## Concept Report Form

<b>Project Name</b>	Bridge over Branch									
<b>PIN</b>	134883.00									
<b>Route Information</b>	<b>Route</b>	<b>NHS (Y/N)</b>	<b>Functional Class</b>			<b>City</b>		<b>County</b>		
	S.R. 54	No	Urban Major Collector			Brownsville		Haywood		
<b>Project Information</b>	<b>Begin Log Mile</b>	<b>End Log Mile</b>	<b>AADT<sup>1</sup></b>	<b>Design Hour Vol. (DHV)<sup>1</sup></b>	<b>Truck %<sup>1</sup></b>	<b>Design Speed (MPH)</b>	<b>Posted Speed (MPH)</b>	<b>Base Year</b>	<b>Design Year</b>

**Comment Resolution: 134883.00, Haywood, SR 54, Bridge over Branch (TMA)**

**CROSS-SECTION DETAIL**

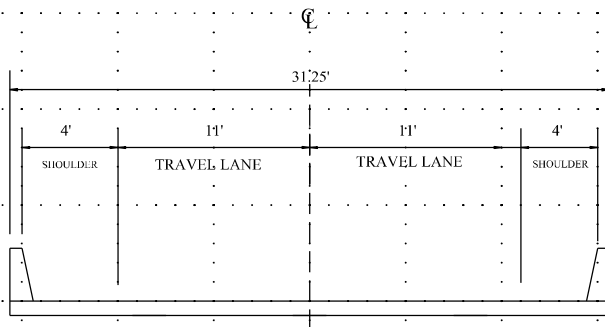
<b>Comment Stage</b>	<b>Division</b>	<b>Commenter</b>	<b>Date</b>	<b>Comment</b>	<b>Comment Addressed?</b>	<b>Additional Notes</b>
Draft Report Review (OSD2)	Alternative Delivery	Derek Link	10/8/2024	Is there supposed to be a full 4' shoulder crossing the bridge? If so measure the 4' from toe of parapet wall instead of top.	Yes	This report was initiated prior to the revision of the applicable standards. The budget for the timber bridge program was developed based on the previous standards. There is an increase in shoulder width from existing, and no crash issues exist at this location. However, further refinement of the cross-section design will be addressed in Phase 1 of the project.
Draft Report Review (OSD2)	Alternative Delivery	Derek Link	10/8/2024	Guardrail depicted in the SE corner is extending past the proposed ROW limits. If proposing to extend to this point will easement be required?	Yes	The guardrail will stay within TDOT's ROW.
